Land Use Committee Report

City of Newton **In City Council**

#27-20 Petition to allow Mixed Use Transit Oriented Development at Riverside Station
MD 399 GROVE OWNER, LLC/RAMIREZ CONCORD, LLC/BH NORMANDY RIVERSIDE, LLC/MASSACHUSETTS BAY TRANSPORTATION AUTHORITY petition for SPECIAL PERMIT/SITE PLAN APPROVAL to construct a mixed use, transit-oriented development of residential units, office, retail, personal services, restaurant, hotel, and related commercial uses not to exceed 1,025,000 square feet of gross floor area, with residential uses comprising not less than 60% of the total gross floor area with a residential density of not less than 800 square feet per unit with not less than 560 units nor more than 620 units with special permit relief and/or waivers as follows: as to dimensional standards, a development of more than 20,000 square feet of gross floor area, building height of up to 170 feet, buildings up to 11 stories, Floor Area Ratio of up to 2.5, beneficial open space of not less than 15%, increase of height of certain buildings with the Grove Street Area Corridor (to the extent necessary), and reduction in setback from Grove Street for certain buildings within the Grov

Station Entrance - Original Plan

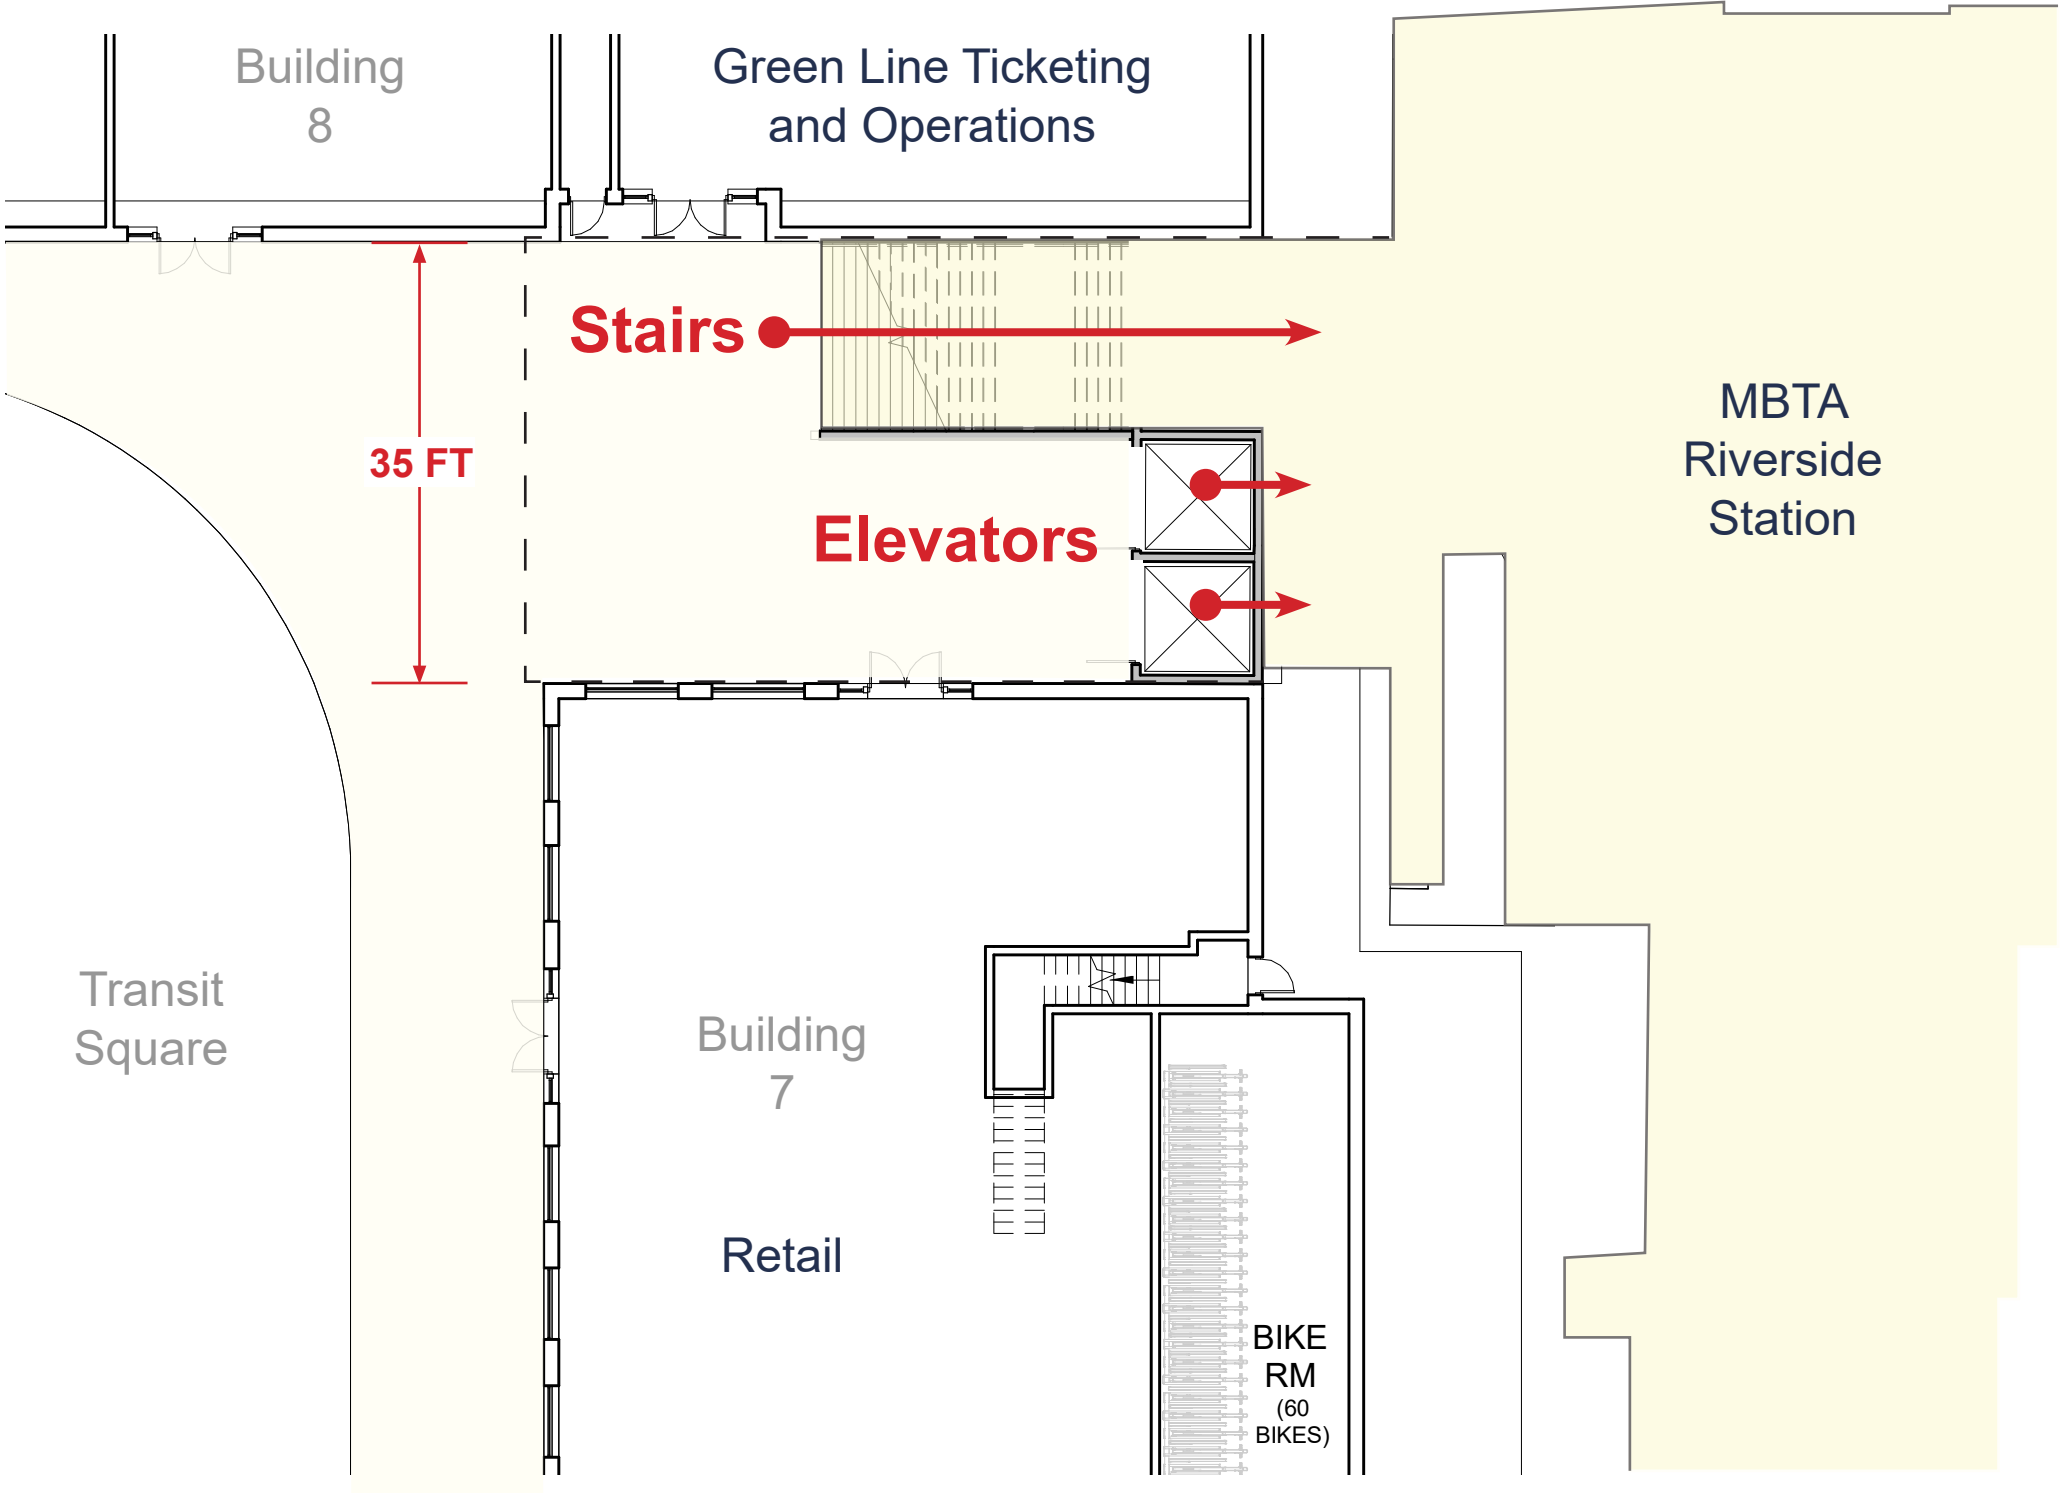
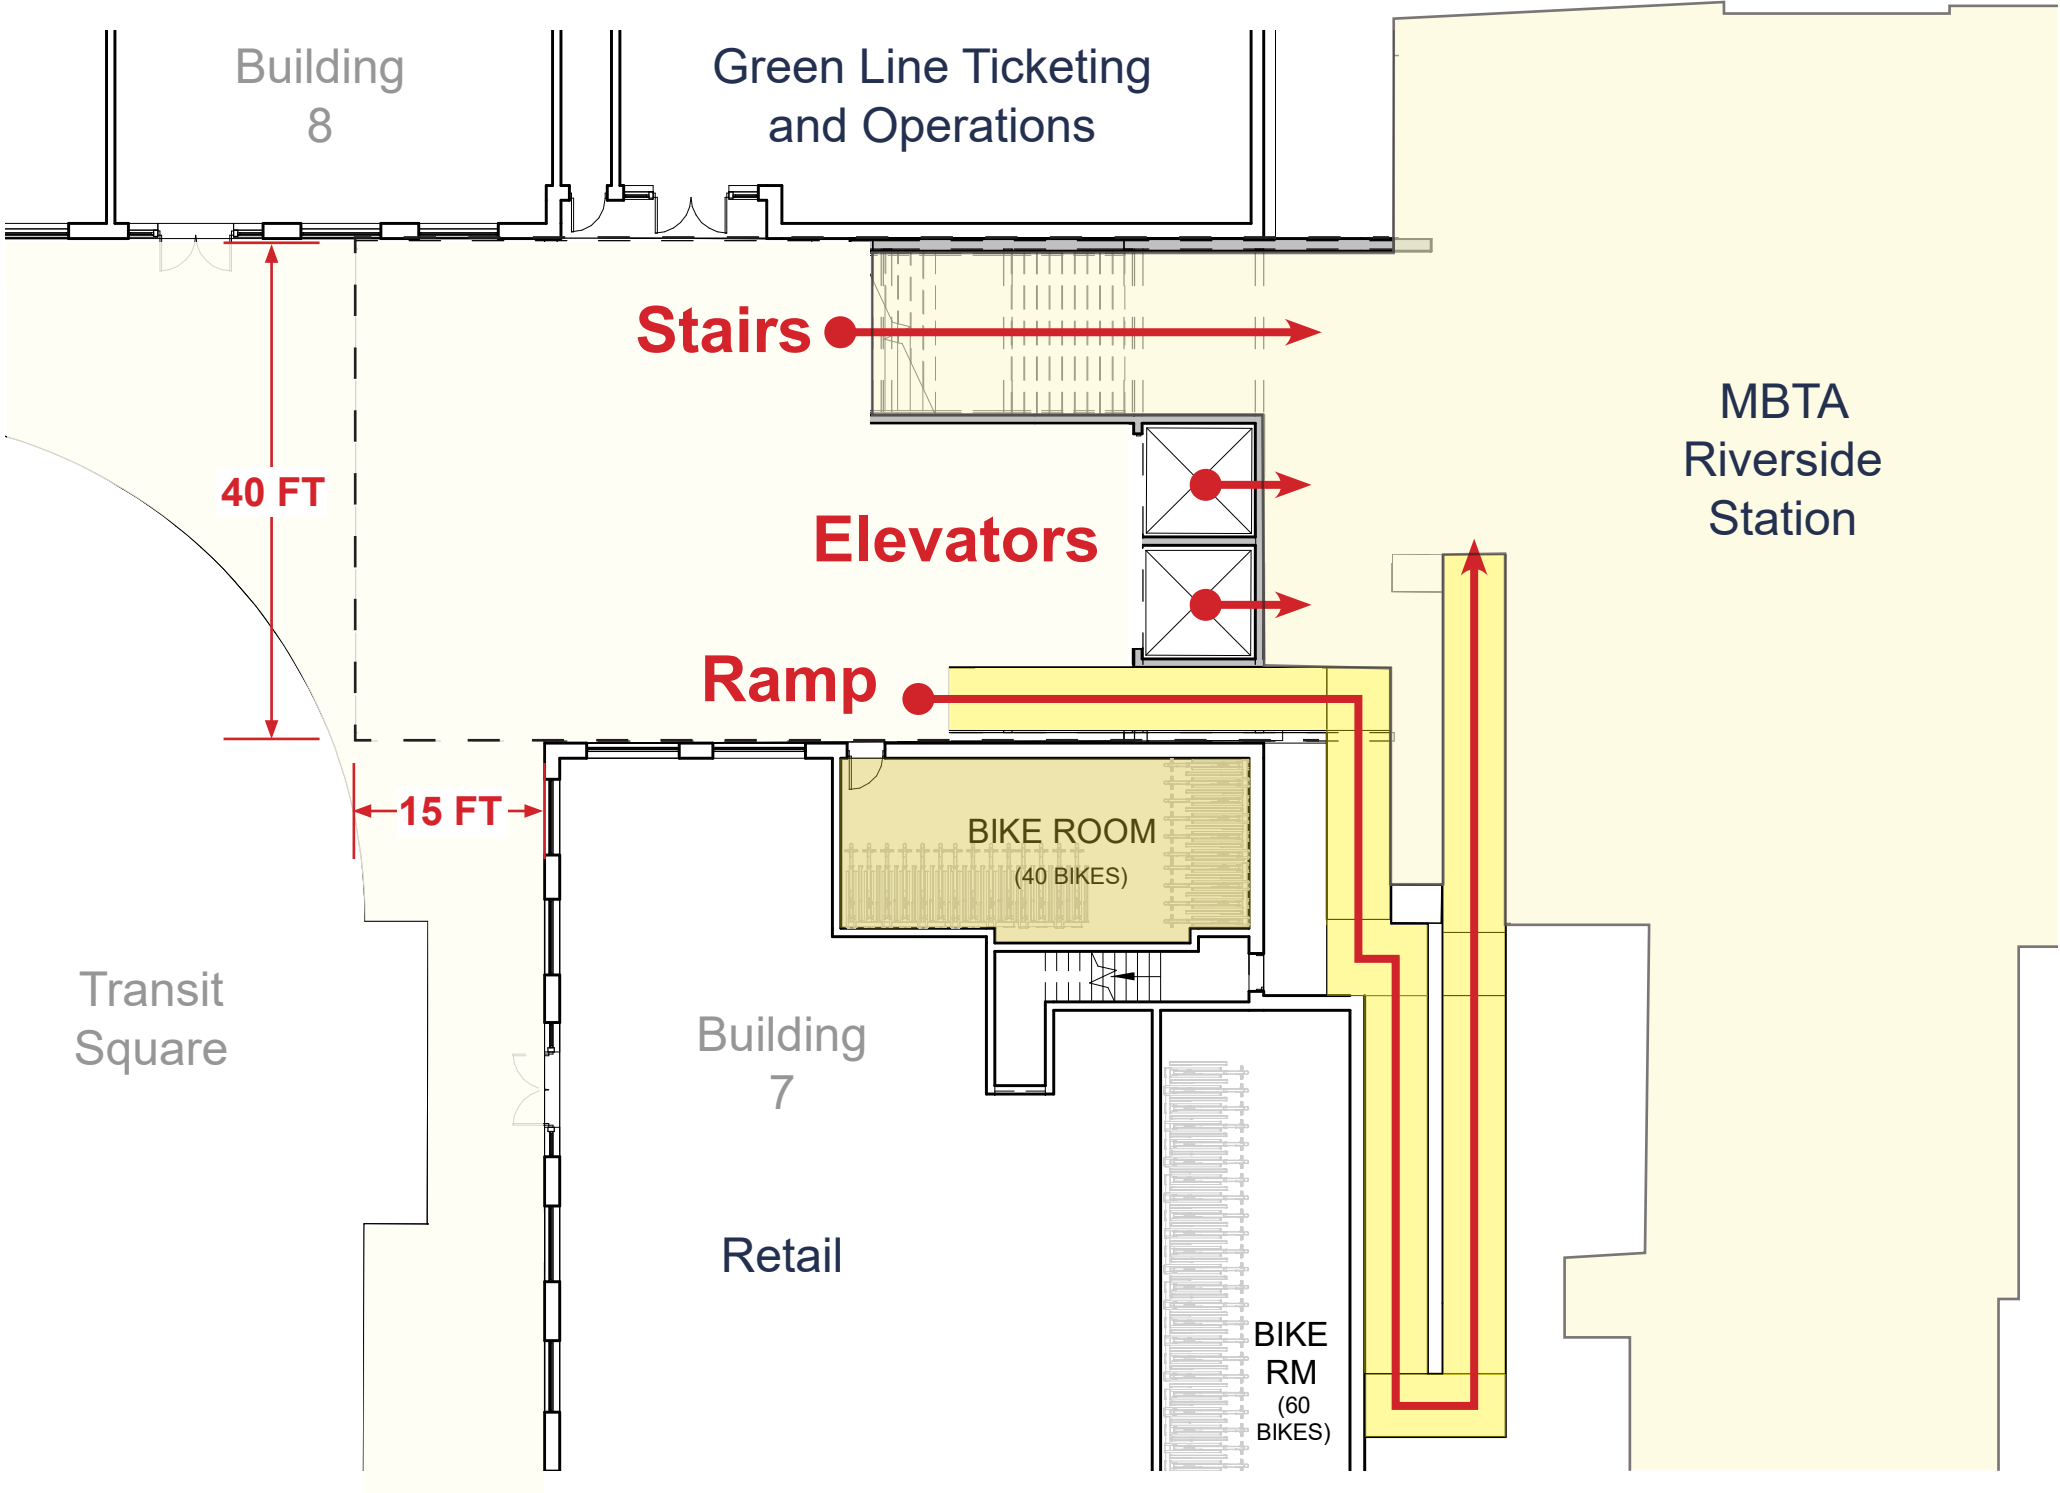
At a prior public hearing, the Committee expressed concern relative to the limited ADA accessibility. The MBTA has given the petitioner the green light to go ahead with a ramp while maintaining the elevators. In order to do this, 5’ has been removed from building 8.

Station Entrance - New Ramp
